November 15, 2016

SUBJECT: Enforcement Petition (10 CFR §2.206) Regarding Exelon's Byron and Braidwood Stations

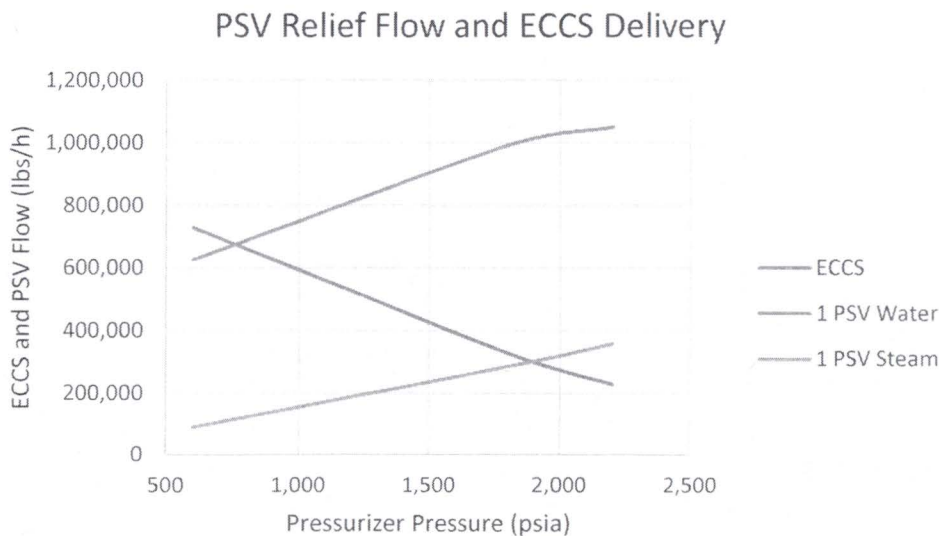
The situation that the Licensee describes, wherein the flow through the open PSV would be matched by the flow that is delivered by the ECCS flow, would be true only after RCS pressure has dropped to very low levels, late in the IOECCS scenario; long after the non-escalation requirement has been violated. At high RCS pressures, the critical (choked) water flow, through the PSV, will be much greater than the ECCS flow that is delivered. Here is an illustration of this relationship for one PSV. This is a conservative depiction, since (1) ECCS flow is high (i.e., the maximum ECCS flow rate is represented), and (2) the PSV relief rate is low (i.e., there could be as many as three stuck open PSVs). At worst, as many as three PSVs could stick open, and create a hole that is equivalent to a 3.7 inch hot leg LOCA.

The figure shows that ECCS flow rate will not exceed the PSV water relief rate until the RCS pressure approaches the accumulator injection setpoint (about 600 psia).

{Error 4} The Licensee claims that ECCS flow will match PSV water relief rate.
